Friday 23<sup>rd</sup> April, 2021

**Re: Product Change Notification for Harwin packaging.**

*Left = Previous plastic cap, Right = New metal cap*

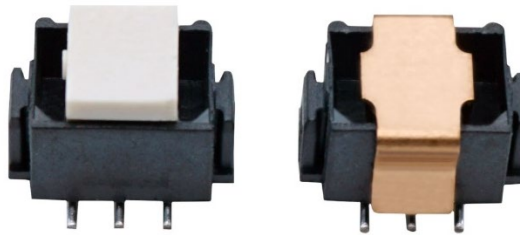
Please be advised that the pick and place cap used on male Datamate connectors (M80 Series) has been changed from a plastic cap to a metal stamped cap. This reverses a previous PCN dated 8<sup>th</sup> January 2020, following further investigation and improvement of the previous metal cap design.

As you can see from the profiles, a small amount of height has been reduced, and changes to the settings on your pick and place machines may be required.

The connector design itself is unchanged. Please note that we are no longer prepared to supply the plastic cap once stock of the existing packaging is exhausted.
